ALERT SERVICE BULLETIN

210-17-12
21 March 2017

MODEL AFFECTED: 210

SUBJECT: **MAGNETIC BRAKE ASSEMBLY 204-001-376-003
INSPECTION AND REPAIR OF.**

Figure 2. Magnetic brake assembly with stops properly installed.

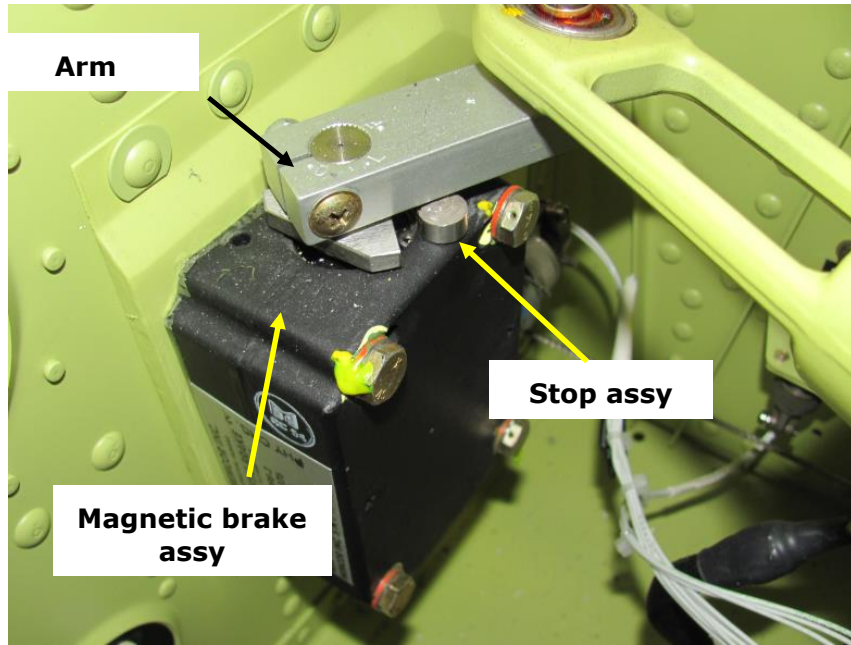
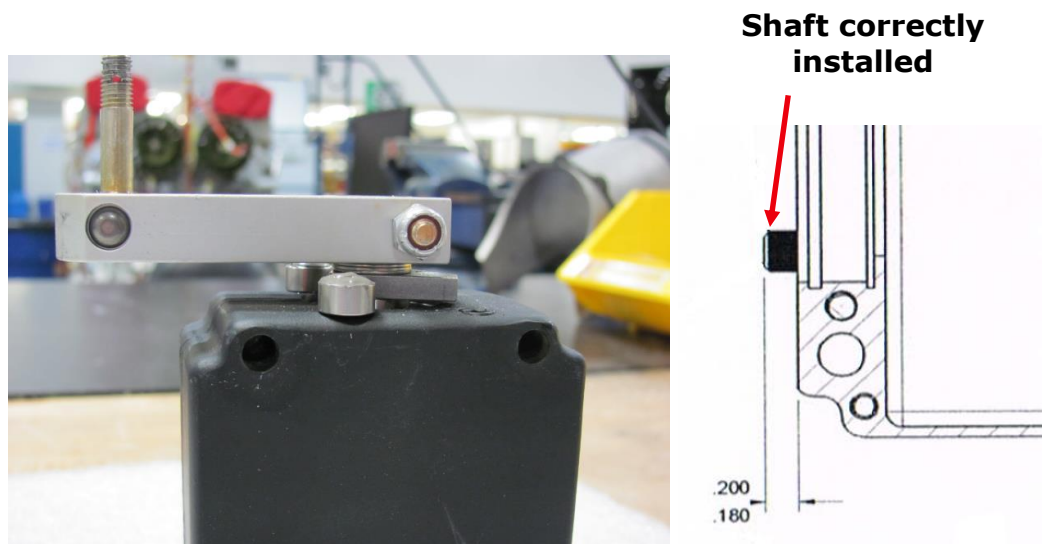
1. Prepare the helicopter for maintenance.
2. Gain access to the cyclic and anti-torque magnetic brake assembly.
3. Perform a detailed visual inspection of the stop assemblies (Figures 1 and 2). Figures 3 and 4 show a stop assembly found debonded.

8. The shaft should protrude from the housing surface between 0.180 inch and 0.200 inch. (Figure 2)
9. Allow sufficient time for the adhesive (C-317) to cure (24 hours at 70 to 95 °F).

Figure 3. Stop assembly with debonded shaft.

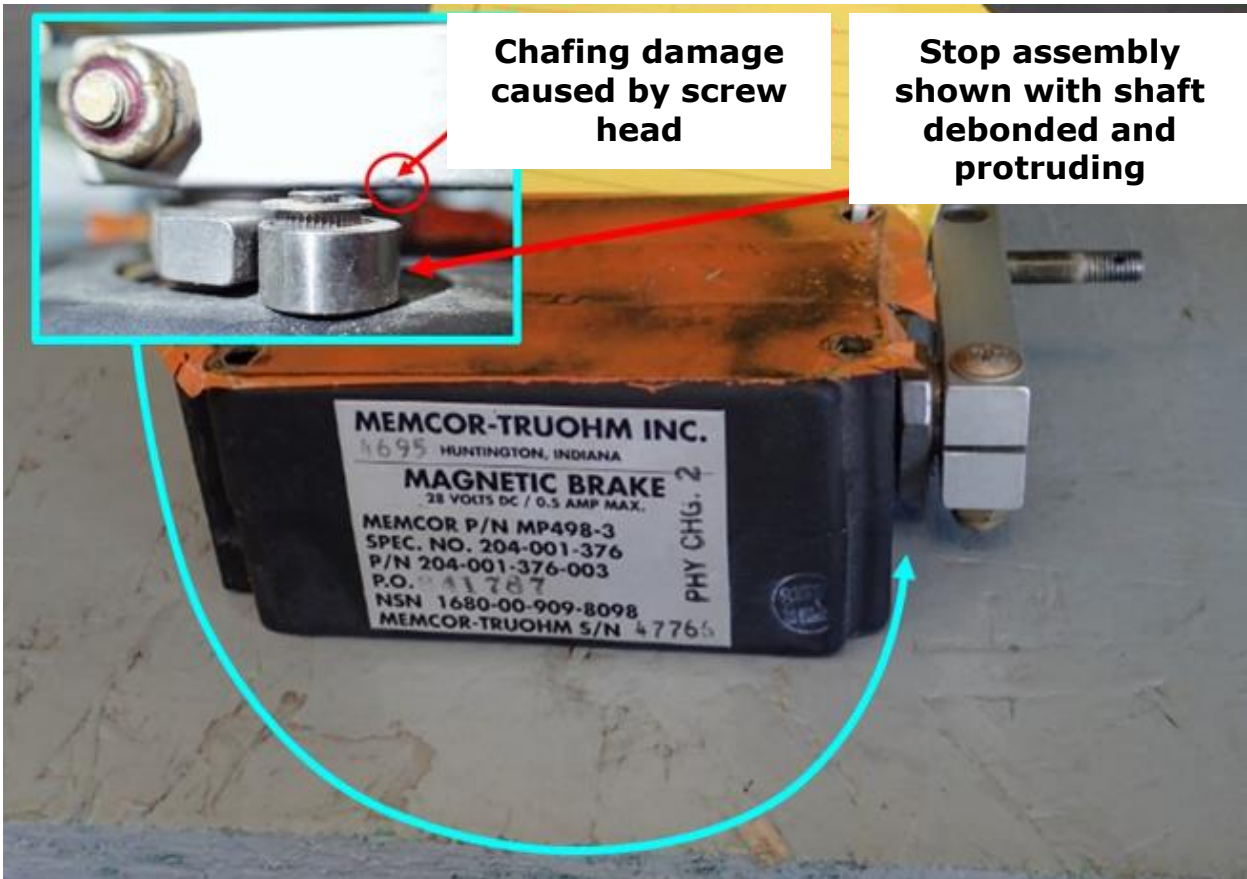
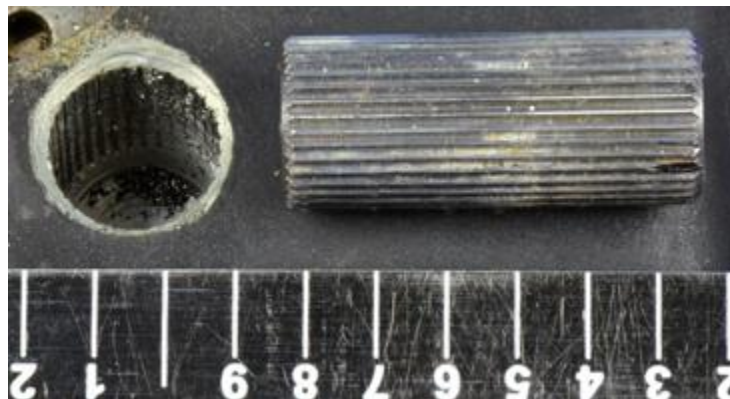
4. Pull on the stop assembly by hand to verify if the stop shaft is debonded from the housing assembly. If the shaft shows evidence of debonding, inspect the lower side of the arm for possible chafing damage. Repair allowable damage and then accomplish Part II. The maximum allowable mechanical damage is 0.030 inch. Repair allowable chafing damage as follows:

4. Remove the stop assembly from the housing. (Figure 4)
5. Thoroughly clean adhesive residue from the shaft and the housing bore. If splined stop requires removal from the shaft, index mark the stop, the shaft and the housing to ensure stop installation at the same location.

- a. Using 220 grit of finer abrasive cloth or aluminum oxide paper, polish out mechanical damage found within the allowable 0.030 inch.
 - b. Apply aluminum alloy chemical film treatment to the repaired area (BHT-ALL-SPM).

Figure 5. Adjustable Stop Assembly Installation

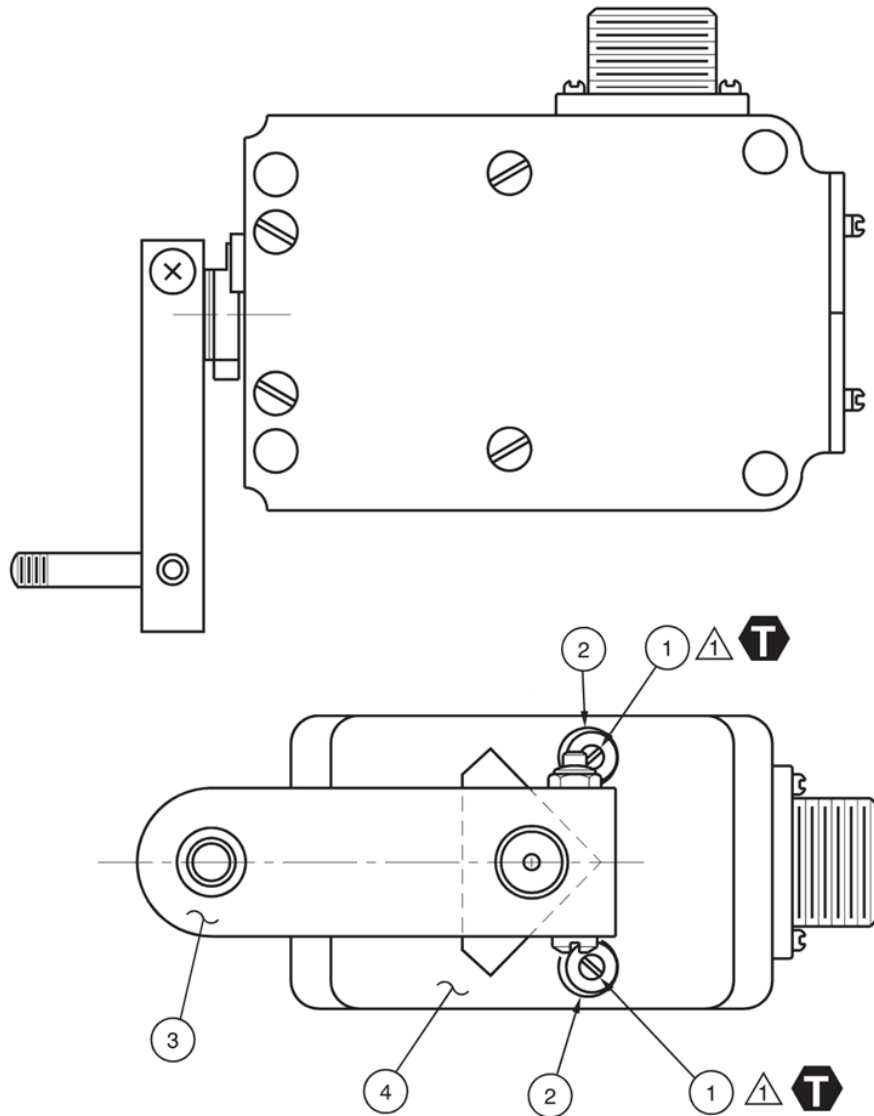
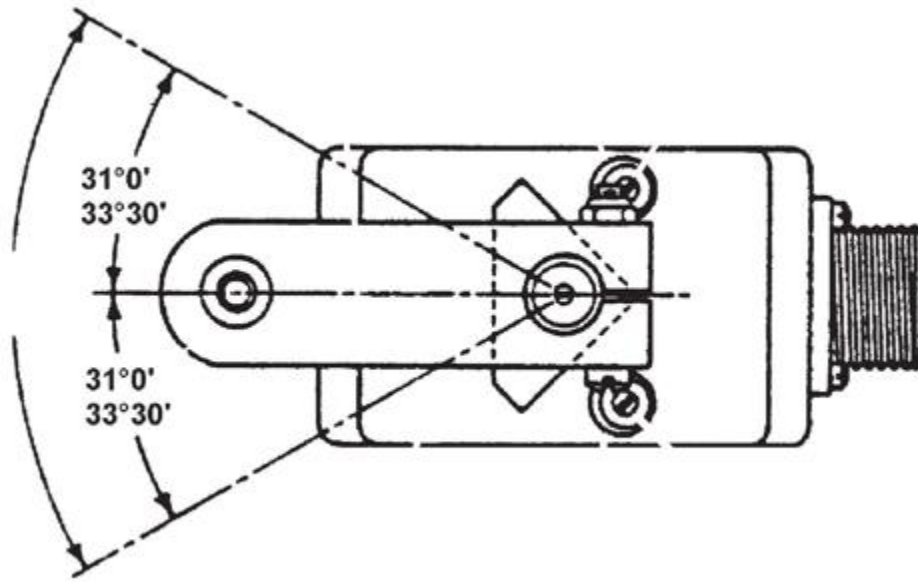
10. Verify/adjust stop limits to achieve the arm assembly travel. If the screw is removed from the shaft, reinstall with adhesive (C-320) and torque to 5-10in-lb. (Figures 5 and 6)
